APPLICATION NO.	FILING DATE	FIRST NAMED INVENTOR	ATTORNEY DOCKET NO.	CONFIRMATION NO.
10/801,858	03/17/2004	Hermann Baumann	080443.53218US	1965

Office Action Summary

2. Applicant is required to insert the following paragraph on Page 1, after the title of "Arrangement for an Exhaust Gas Turbocharger With a Carrier Housing":

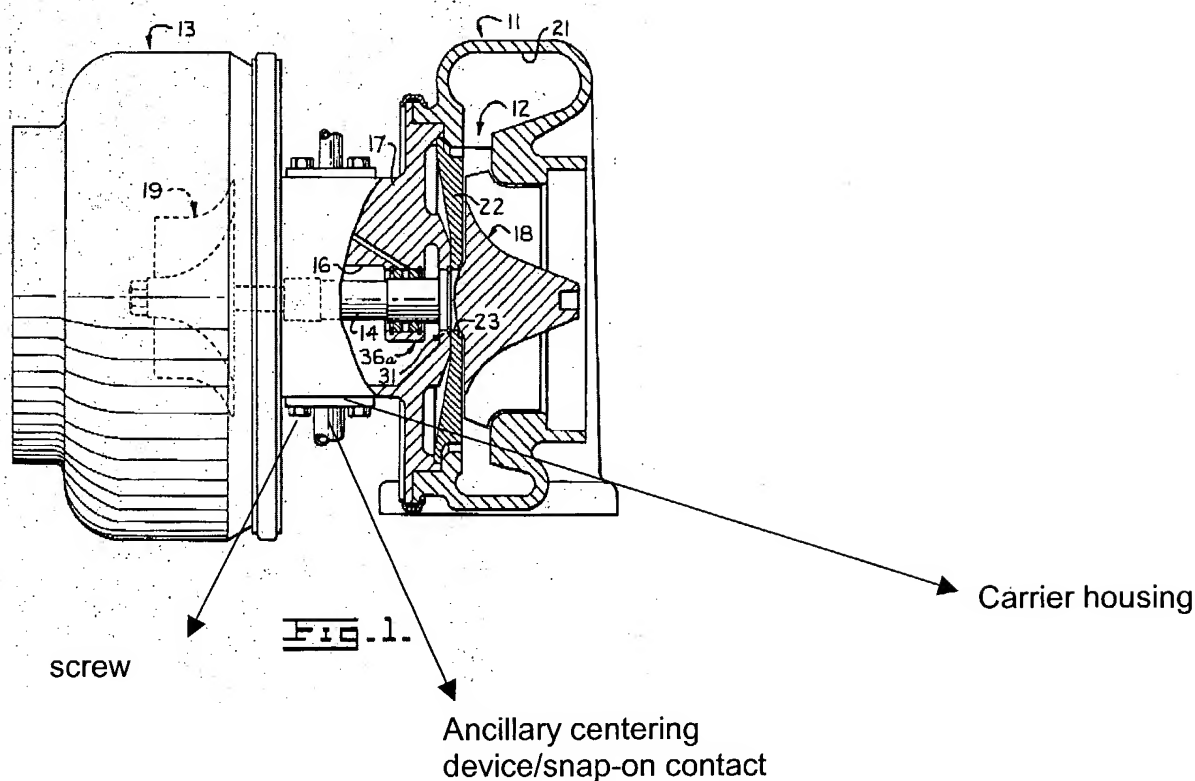
Miller discloses an arrangement for an exhaust gas turbocharger with a carrier housing (Not Numbered), the exhaust gas turbocharger comprising:

a compressor wheel (19),

a turbine wheel (18),

a bearing housing (17), and
a shaft (14) adapted to connect the compressor wheel (19) and the turbine wheel (18),

wherein the exhaust gas turbo charger is attached to the bearing housing (17) with the carrier housing (Not Numbered) by way of a fastening element, which is oriented in a direction perpendicular to an axis of rotation of the shaft (14) (See attached Figure 1);

wherein an ancillary centering device for orientation of the exhaust gas turbocharger on the carrier housing is provided on the bearing housing (See attached Figure 1);

wherein the ancillary centering device is in the form of a snap-on contact (See attached Figure 1);

wherein, by way of the snap-on contact, lubricant is conducted out of the bearing housing and into the carrier housing (See attached Figure 1, Column 3, lines 23-28).

Miller discloses the invention as recited in the rejection of claim 1, and further discloses the fastening element is in the form of screws (Not Numbered, See attached Figure 1); an ancillary centering device for orientation of the exhaust gas turbocharger on the carrier housing being provided on the bearing housing (17); the ancillary centering device being in the form of a snap-on contact; and by way of the snap-on contact, lubricant being conducted out of the bearing housing and into the carrier housing See attached Figure 1, Column 3, lines 23-28).
